Chapel Lane, Widnes: Response to Halton BC and Knowsley Council

Ref: VE/ITM19092-002A
Date: 1 May 2025

- 1.1 This Technical Note responds to highways comments received from Halton Borough Council (HBC) and Knowsley Council (KC) in relation to Taylor Wimpey's development proposals at Chapel Lane, Widnes (Outline Application Ref: 23/00244/OUT (HBC); 23/01037/OUT (KC)). The Council's comments were set out in correspondence dated 13th March 2025.
- 1.2 Given the degree of overlap between the two sets of comments, this note seeks to respond to the issues raised in both authorities' responses. This note considers issues relating to the following aspects of the proposals – each is considered in turn below:
- Off-Site Active Travel Package
 - Proposed Access onto Chapel Lane – Primary Access and Emergency Vehicle Access
 - Internal Site Layout
 - Other Issues

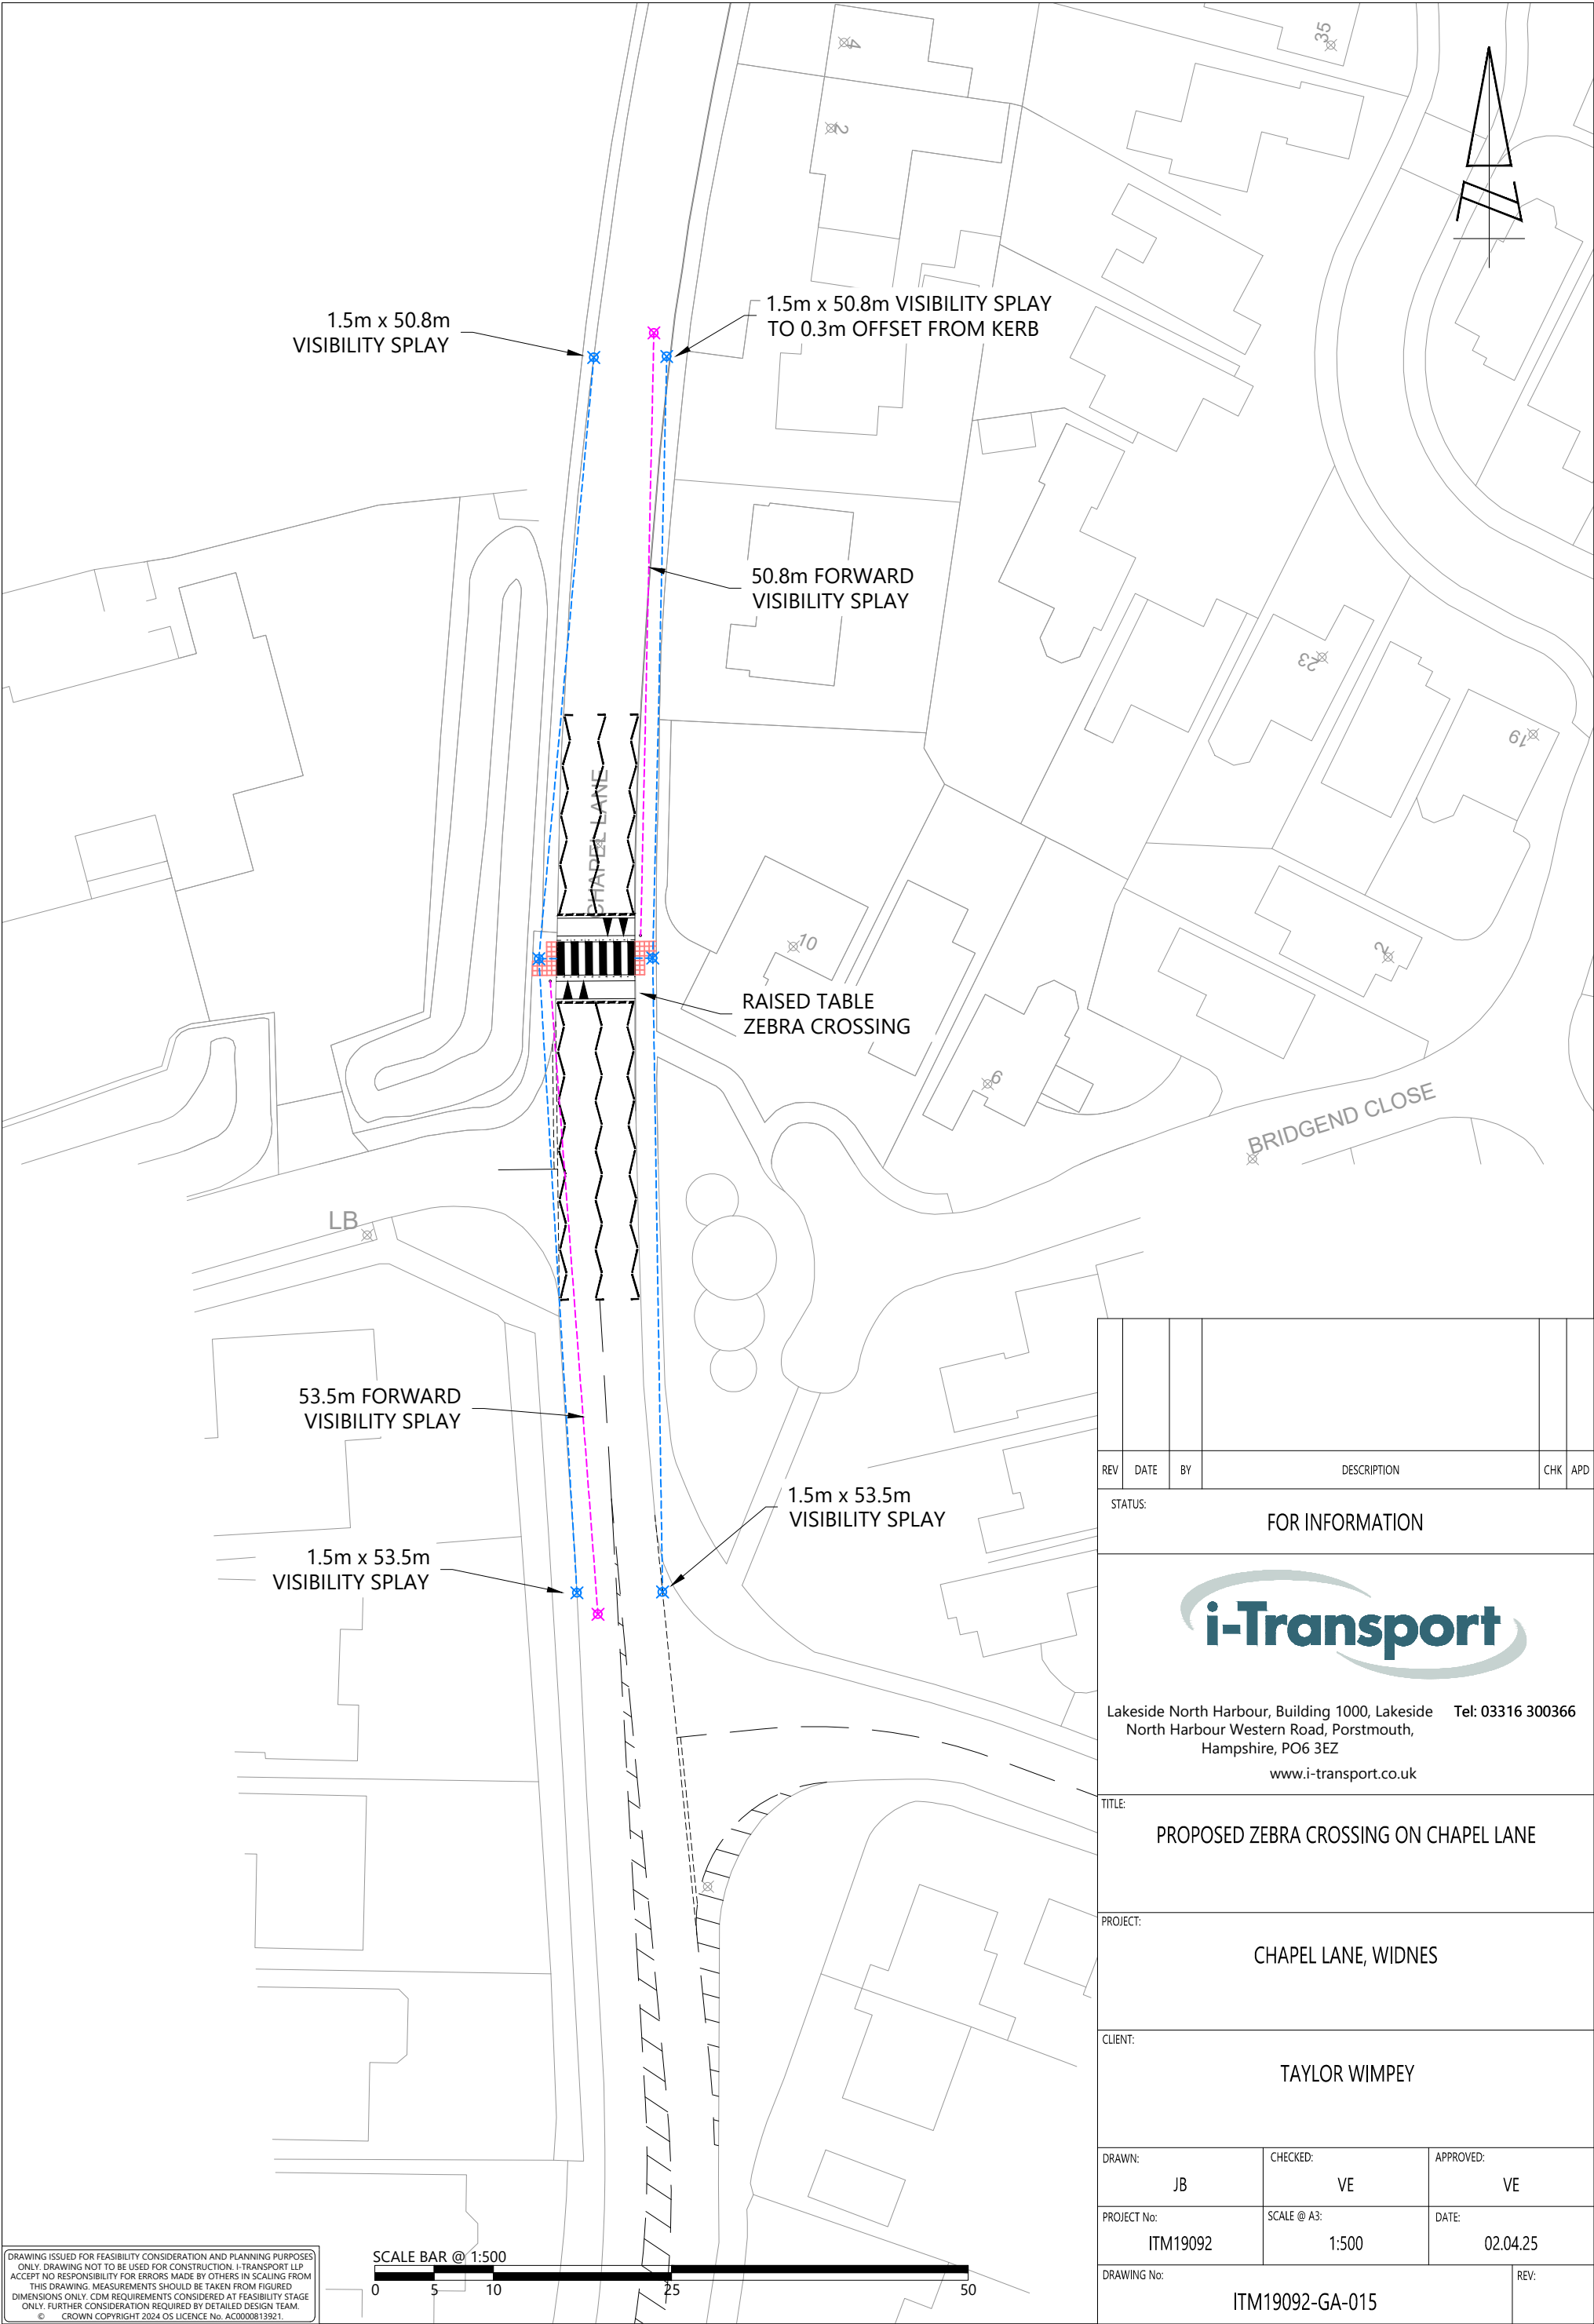
As part of the enhanced package of measures, it is now also proposed that on-street cycle lanes are provided along Chapel Lane / Prescott Road between the junction of Chapel Lane / Parklands and the Queensbury Way roundabout. This provision will take the form of protected on-road cycle lanes, created by removing the existing central hatching along this section of the route and protected using 'armadillo' lane separators. The proposals are illustrated in Drawing ITM19092-GA-018 Rev A (**Appendix B**).

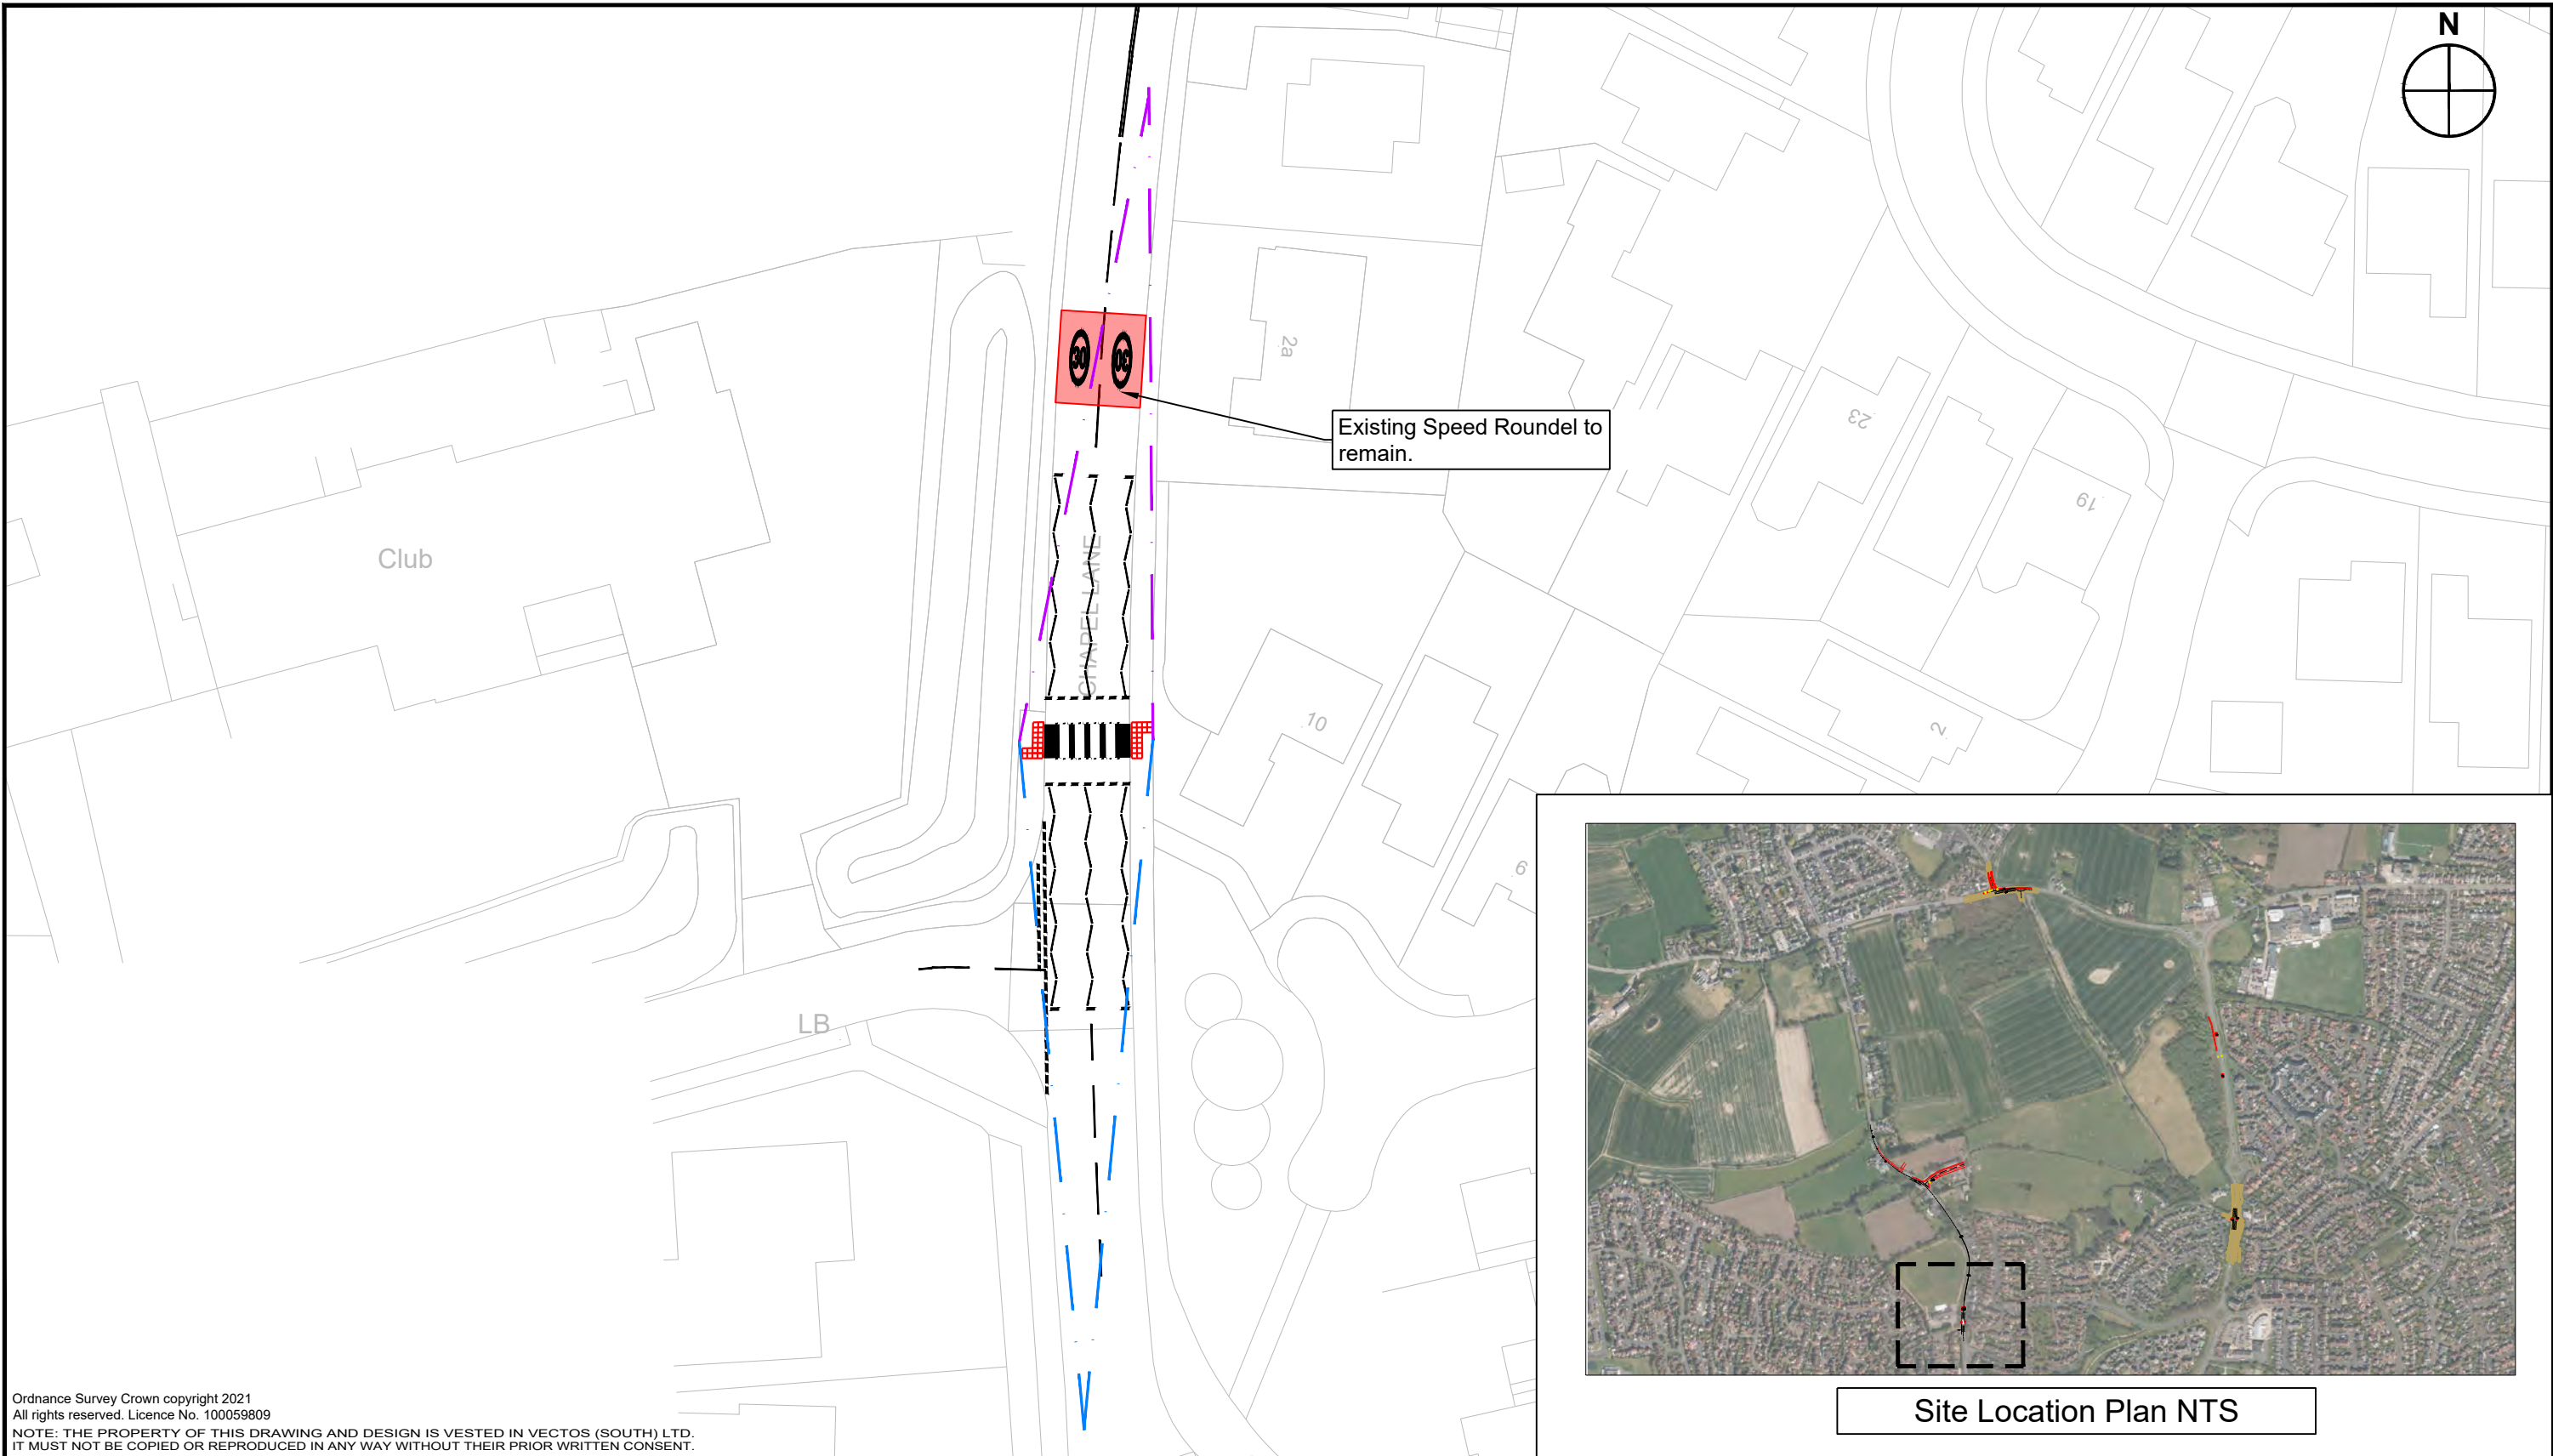
- 2.8 KC has raised concerns regarding the proposed zebra crossing on Chapel Lane citing vehicle speeds, a lack of footway space, reduced visibility / sight lines to the crossing and the proximity of the side road junction (with Parklands). The following points are noted:

- The 85th percentile vehicle speeds on Chapel Lane were recorded as 35mph northbound and 34mph southbound. National design guidance (TSM Chapter 6) confirms that zebra crossings are suitable on roads with 85th percentile speeds up to 35mph.

- With regard to visibility / sight lines, Drawing ITM19092-GA-015 contained at **Appendix C** shows that the required forward visibility to the crossing and pedestrian visibility splays from the crossing can be comfortably achieved in both directions at the crossing, taking account of the observed vehicle speeds. Appropriate maintenance of the vegetation along Chapel Lane (as picked up in the Road Safety Audit) will need to be undertaken to ensure that this does not encroach into the footway, thus maximising the available visibility for vehicles and pedestrians. It would also be possible to locate the zebra crossing on a raised table, both to highlight its location and also to assist in reducing vehicle speeds within the vicinity of the crossing, as shown on the drawing.

- The location of the zebra crossing was chosen to align with the commencement of the footway on the western side of Chapel Lane, and links with the pedestrian route from Cornerhouse Lane. This provides direct access to the sports club, café and beyond into Parklands and is on a natural desire line for pedestrians travelling to / from the development and the north. TSM Chapter 6 also recommends that where crossings are placed near side road junctions that there is sufficient space for at least one waiting vehicle between the crossing and the junction, which can be achieved in the proposed location.

- The zebra crossing would form part of the overall traffic calming scheme along Chapel Lane, designed to reduce vehicle speeds and encourage active travel movements. The future vehicle speeds are therefore expected to be lower than current observations and therefore the provision of a zebra crossing needs to be viewed within the context of the future conditions along Chapel Lane.

Drawing No. 216175_PD14 Rev F – Chapel Lane Zebra Crossing

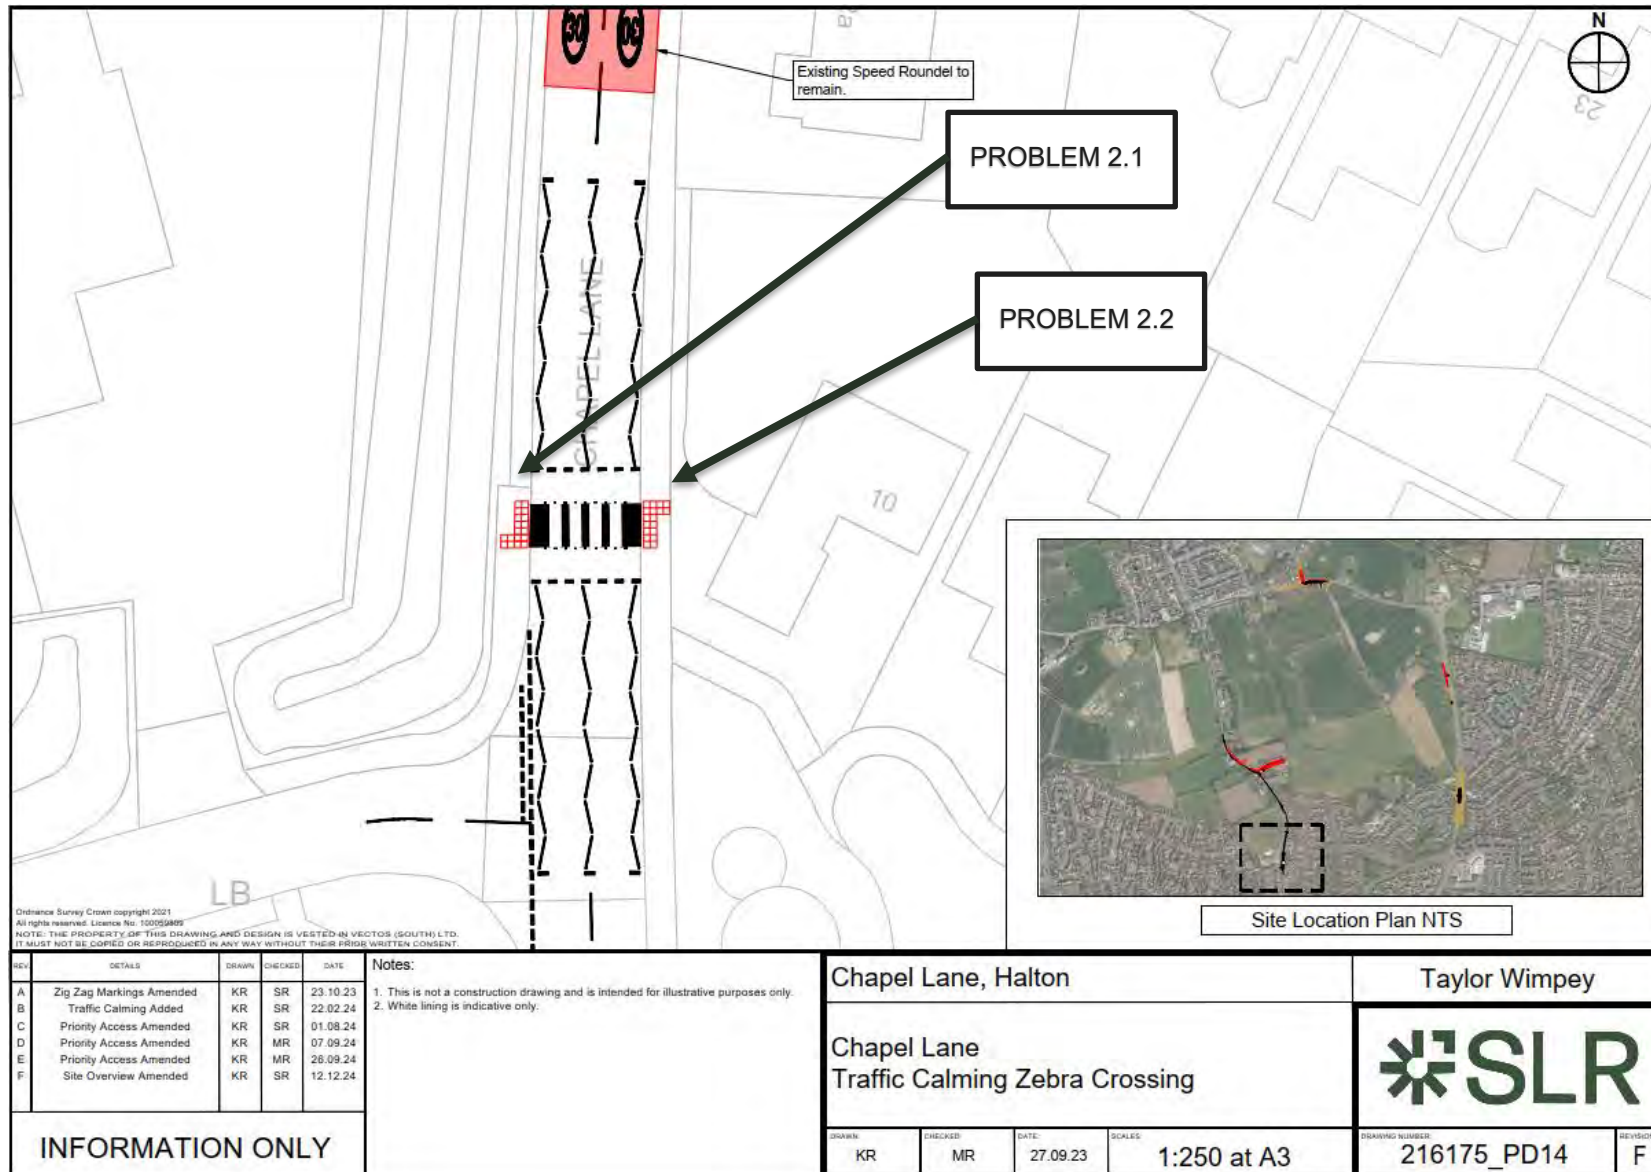
2.1 Problem.

Location: Proposed zebra crossing western side.

Summary: Forward visibility to the western side of the crossing may be obscured for southbound vehicles by existing vegetation potentially leading to injudicious crossing movements and collisions between pedestrians and vehicular traffic.

Onsite observations noted that the forward visibility to the western side of the proposed zebra crossing may be obscured for southbound drivers by the presence of existing vegetation at the end of the pedestrian footway. If the required forward visibility is not achieved on either side of the crossing this design arrangement may lead to injudicious crossing movements potentially causing overshoot / late braking by drivers and collisions with pedestrians on the crossing

2.2 Problem.

Location: Proposed zebra crossing eastern side.

Summary: Forward visibility to the eastern side of the crossing may be obscured by road alignment and existing vegetation potentially leading to injudicious crossing movements and collisions between pedestrians and vehicular traffic.

Onsite observations noted that the forward visibility to the eastern side of the proposed zebra crossing may be obscured by the alignment of the road and the presence of existing vegetation at the back of the pedestrian footway. If the required forward visibility is not achieved on both sides of the crossing this design arrangement may lead to injudicious crossing movements potentially causing overshoot / late braking by drivers and collisions with pedestrians on the crossing

It is recommended that an appropriate visibility splay linked to vehicle speeds on Chapel Lane is provided for both sides of the proposed crossing and that additionally all vegetation encroaching on the public footway is removed.

It is recommended that an appropriate visibility splay linked to vehicle speeds on Chapel Lane is provided for both sides of the proposed crossing and that additionally all vegetation encroaching on the public footway is removed.

RSA PROBLEM	RSA RECOMMENDATION	DESIGN ORGANISATION RESPONSE	OVERSEEING ORGANISATION RESPONSE	AGREED RSA ACTION
2.1	It is recommended that an appropriate visibility splay linked to vehicle speeds on Chapel Lane is provided for both sides of the proposed crossing and that additionally all vegetation encroaching on the public footway is removed.	Agreed. Design drawing has been updated to show appropriate visibility splays in line with the recorded speeds on Chapel Lane. Vegetation is highway maintenance.

2.2	It is recommended that an appropriate visibility splay linked to vehicle speeds on Chapel Lane is provided for both sides of the proposed crossing and that additionally all vegetation encroaching on the public footway is removed.	Agreed. Design drawing has been updated to show appropriate visibility splays in line with the recorded speeds on Chapel Lane. Vegetation is highway maintenance.
